Development Review Board

Tuesday, January 16, 2024, 5:00 PM

ZP-20-712; 362 Riverside Avenue (NAC-R, Ward 1) Douglas Boyden / Benjamin Avery

ZP-23-435; 165 Shelburne Street (RL, Ward 5) Champlain Housing Trust, Inc. / Donal Dugan

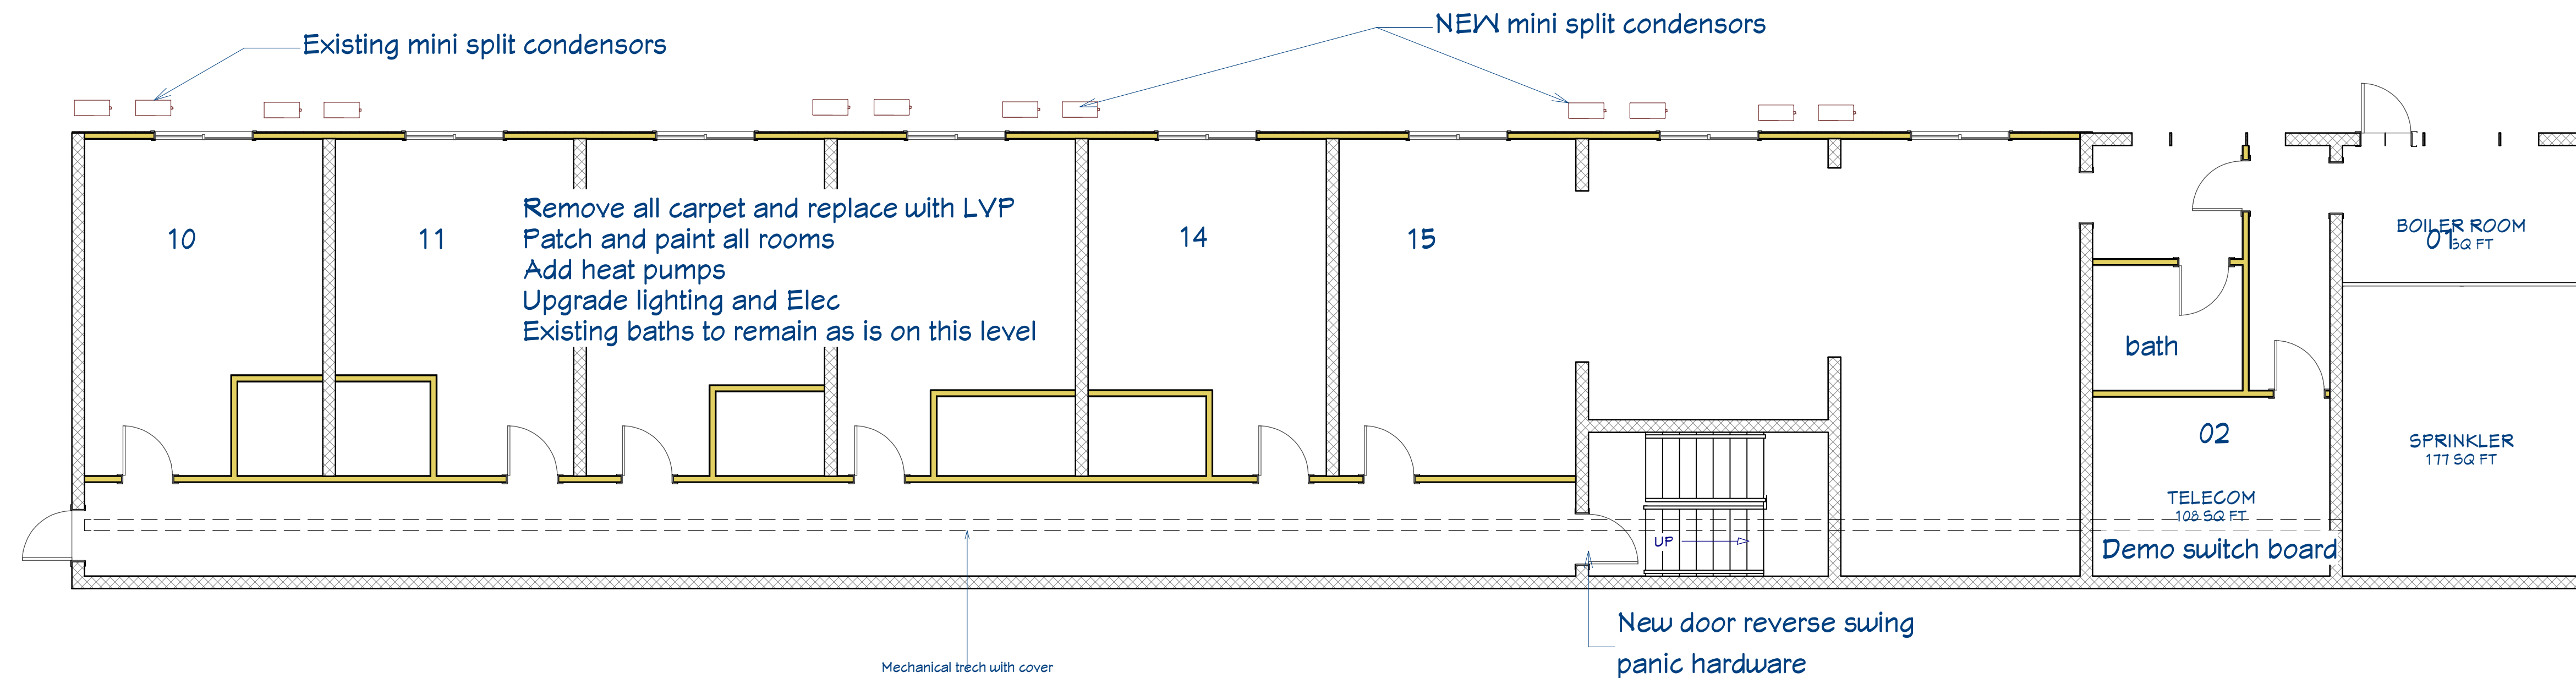
This would allow for proper fire department access to the facade of the building and still have enough turning radii and a functional fire lane next to the building. A fence would not be necessary directly in front of the stair towers which will make the new design look better and save cost.

The walls of the stair towers block access to the walkway and with the added board fence set 4' east of the stair towers, adequate security is achieved to protect all the apartments from uncontrolled access, which I think is the goal here.

There should **not** be space for tents behind the privacy wall which would also be a concern if the fence is too far from the building and if the fence is solid. A more open style vertical board fence would actually be more secure than a solid fence that could prevent management or others from really seeing what is happening behind the fence.

This way, a security fence could be designed to feel like part of the building and made with vertical wood boards held 4" inches apart for light, airiness, be less of a magnet for graffiti, but still be 6' high for security.

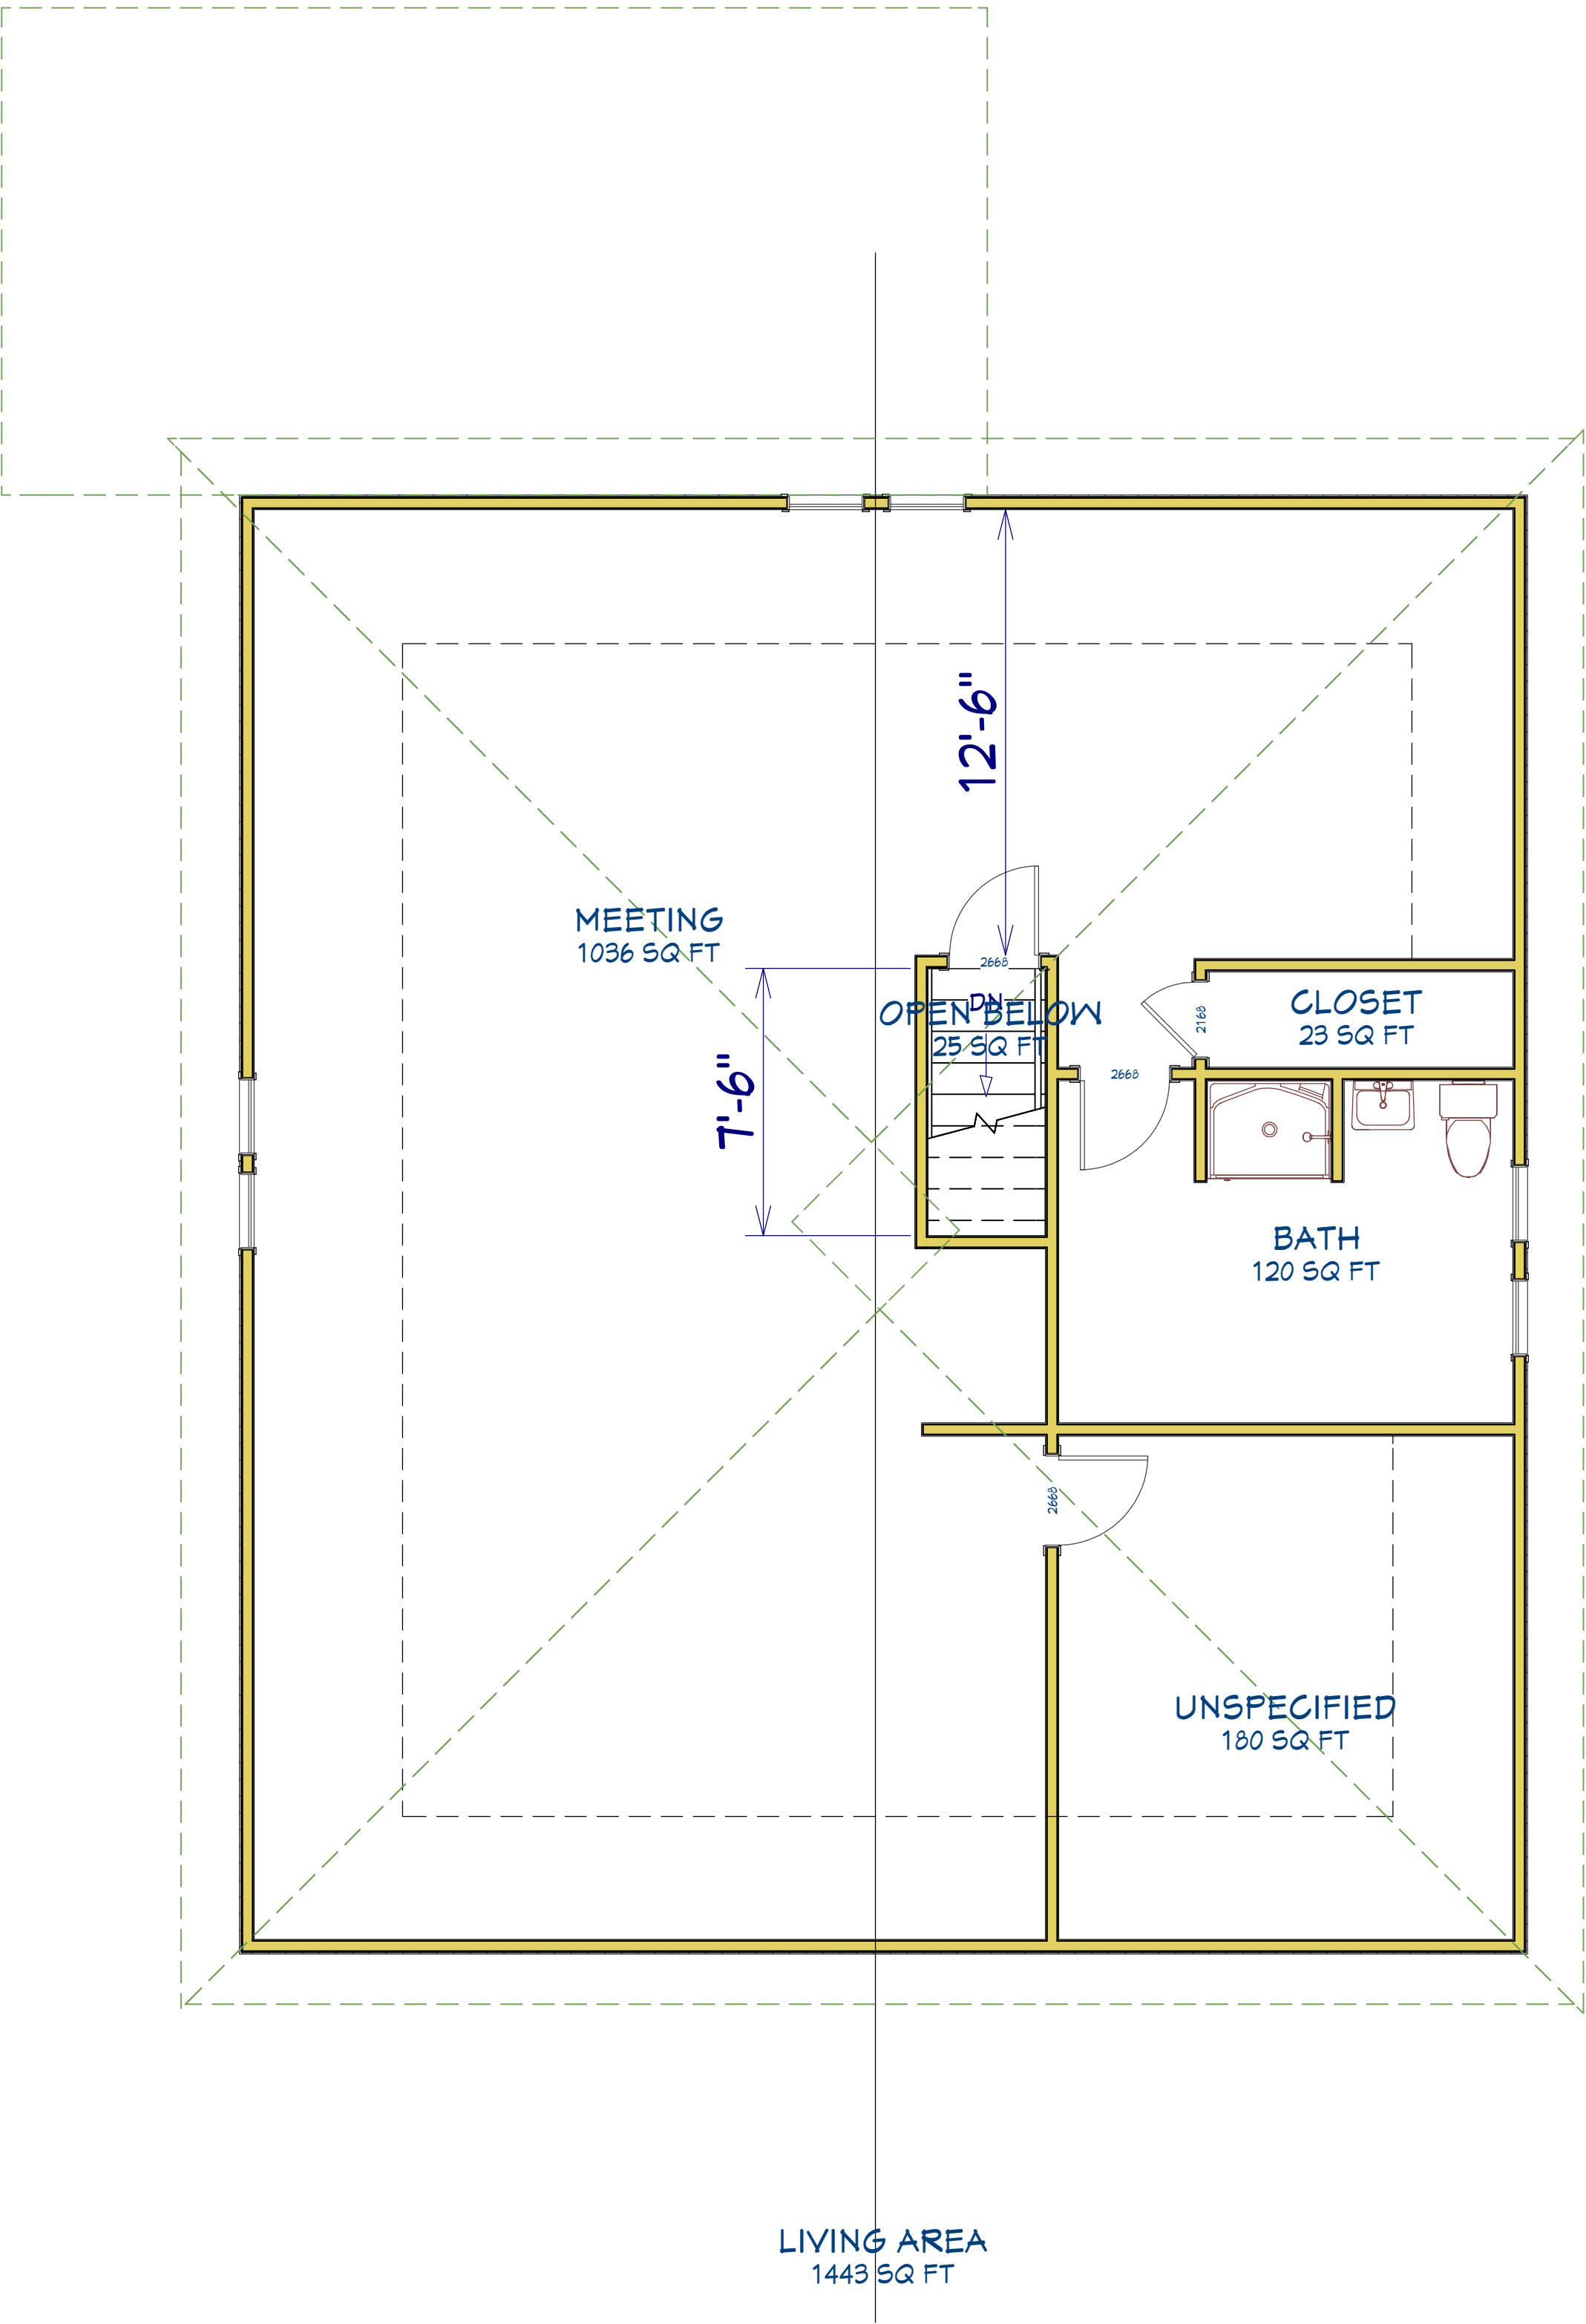
Replace DH with Casement for egress

EGRESS CASEMENT -

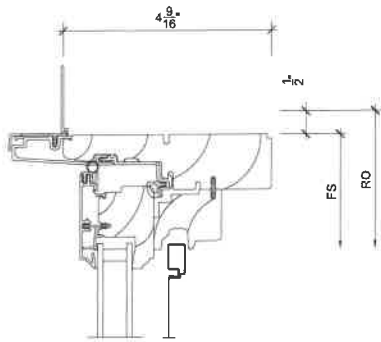
- I had to increase the height to allow us to get to the 5.7 sq. ft egress code.
- Confirm window handing / operation.
- Exact Sizing + Specification To Be Confirmed !!
- Figured as a full frame window, not an insert.

DATE: 28 NOV 23
REVISED:
SCALE: N.T.S.
DRAWING: EXTERIOR IMAGES & NOTES
SHEET: A1.1

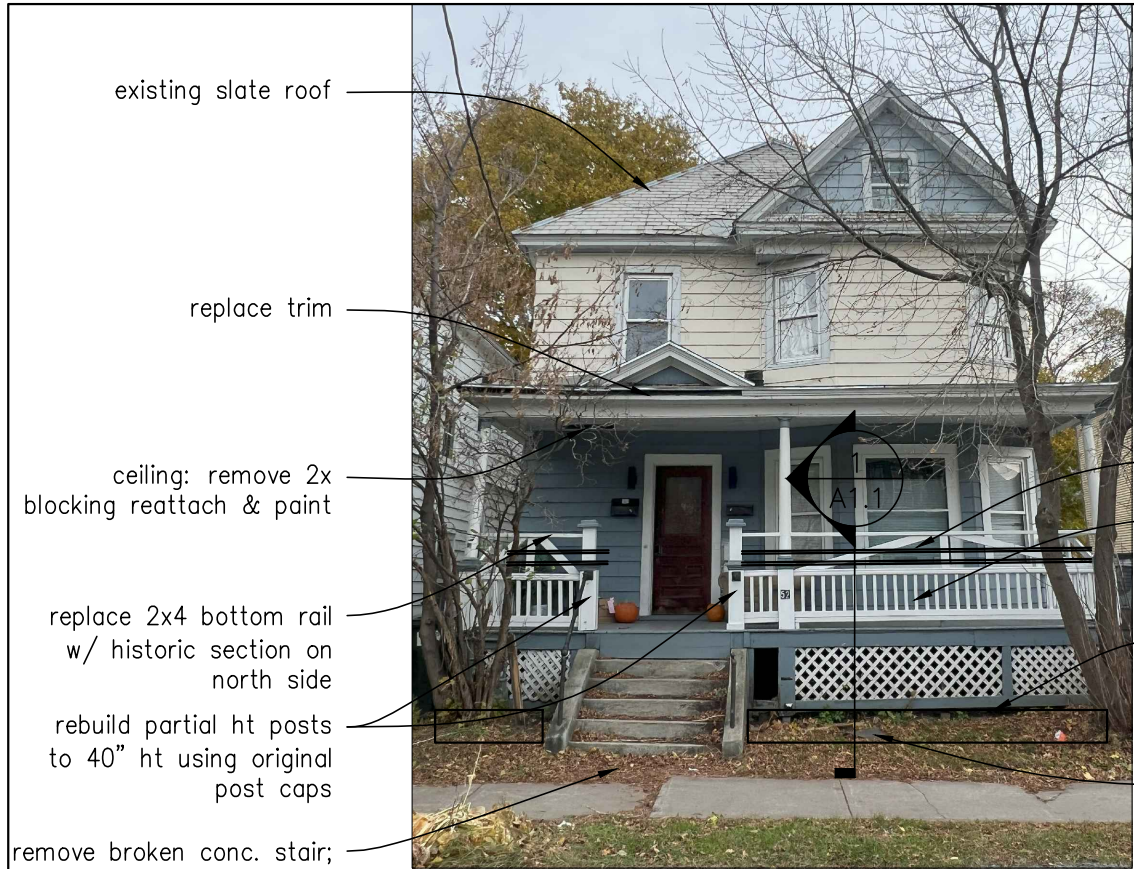
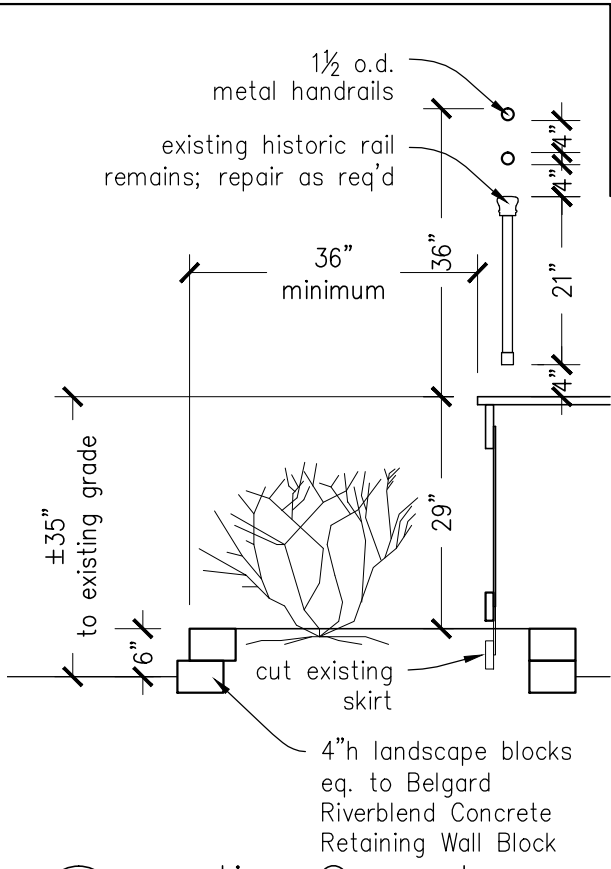
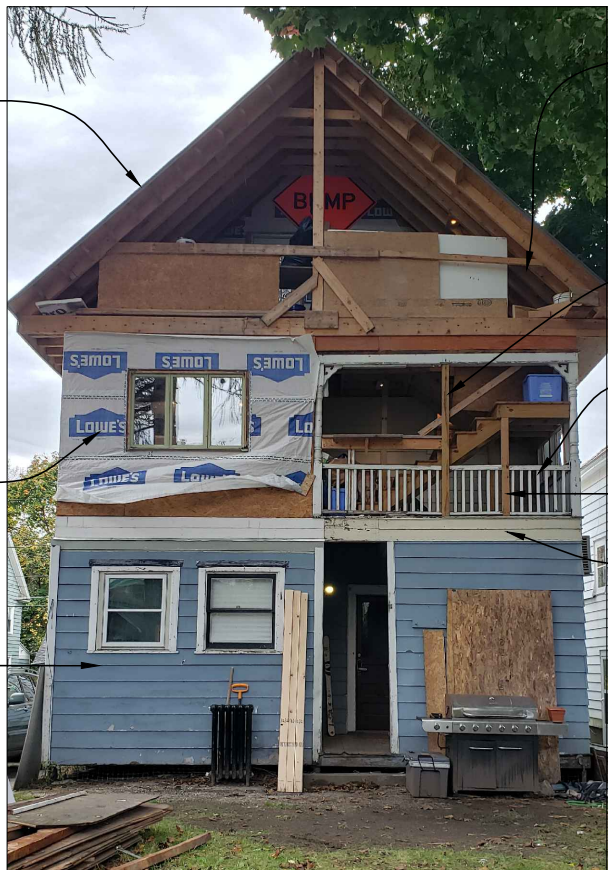
Several permits have been issued to changes to the rear of the duplex. The applicant proposes, as part of this application, to remove the asbestos siding on the west (primary) façade and restore clapboard and shingles; to make porch improvements, to replace trim at the eaves, to remove the concrete front stairs and replace with new framed steps with trex boards, and to restore all wood sash and trim. Reference is made to Plan A1.1.

See Plan A1.1. **Affirmative finding.**

Raised landscaping beds are proposed in front of the porch that will modestly change the grade allowing a more sympathetic porch railing to meet building code. If a commitment is made to creating the planting beds, they shall be maintained and utilized to enhance the building façade. See Plan A1.1. **Affirmative finding as conditioned.**
